66311D-05

S E R V I C E N O T E

66311D

Reliability Improvement of Instrument

CORRECT J207 PLACEMENT – alignment to within $< 0.3\text{mm}$

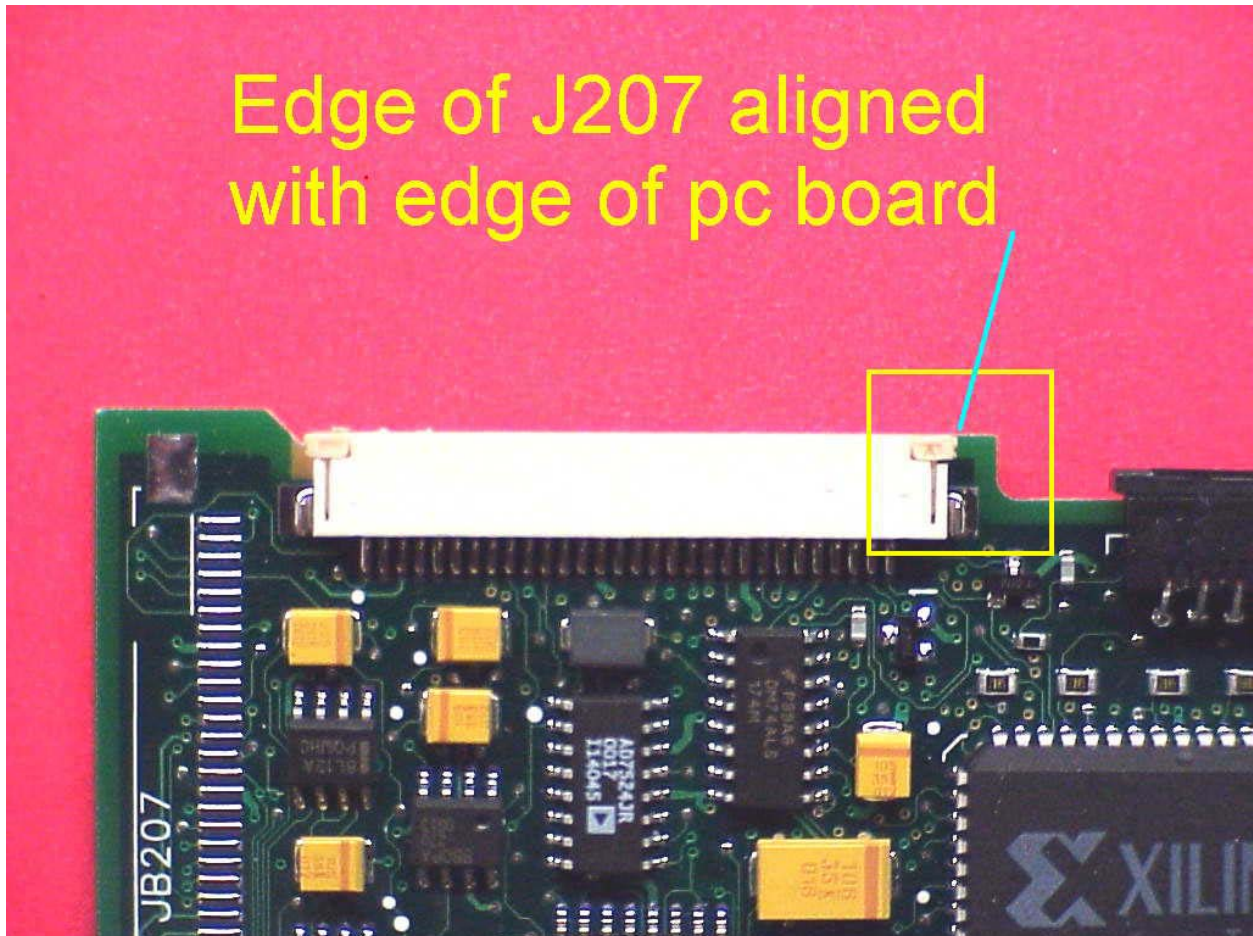
Latent product failure due to misplaced connector J207 on SMT assembly 5064-0018 (GPIB/RS232 interface). Misplacement of J207 could lead to inadvertent contact/shorting of exposed feed-throughs on SMT board. Ultimately, resulting in over-stress of components of damage to SMT board components. Resulting contact could degrade useful life of instrument.

Picture shows connector aligned to edge of SMT board to within $< 0.1\text{mm}$

- 1) Compare placement of J207 to attached photos. Instruments with a “misplaced” J207 should be returned to Agilent for warranty repair.
- 2) Instruments returned to the Service Center for routine calibration should be inspected for this potential defect. Defects should be addressed using Agilent’s unit exchange process with costs being charged to warranty.
- 3) The factory has modified production documentation to include visual inspection and specific electrical testing for this potential short.
- 4) Factory is maintaining feedback to SMT board supplier regarding quality of assembly.

INCORRECT J207 PLACEMENT – misaligned by $> 0.3\text{mm}$

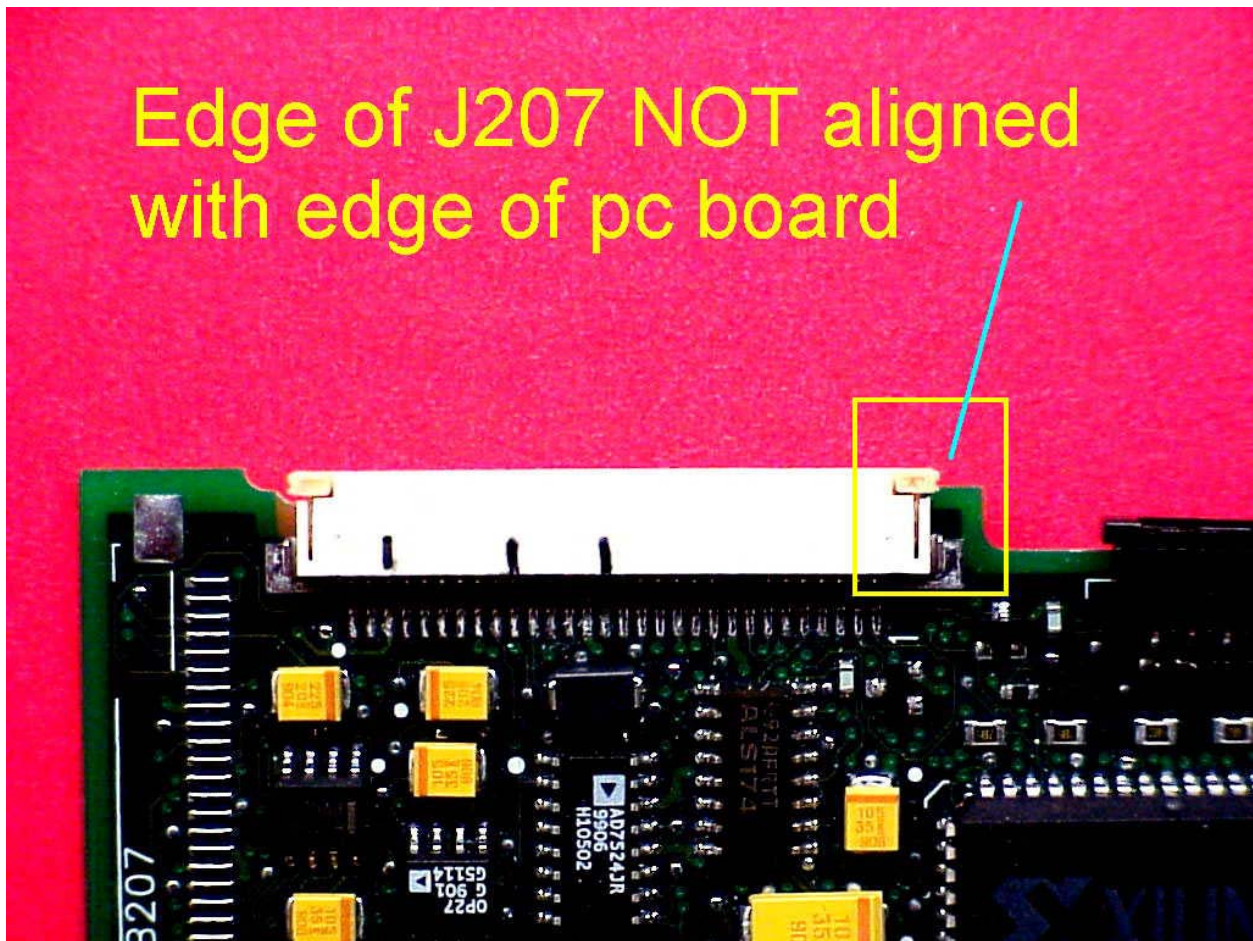
Picture shows connector extending past edge of SMT board by $>1.2\text{mm}$
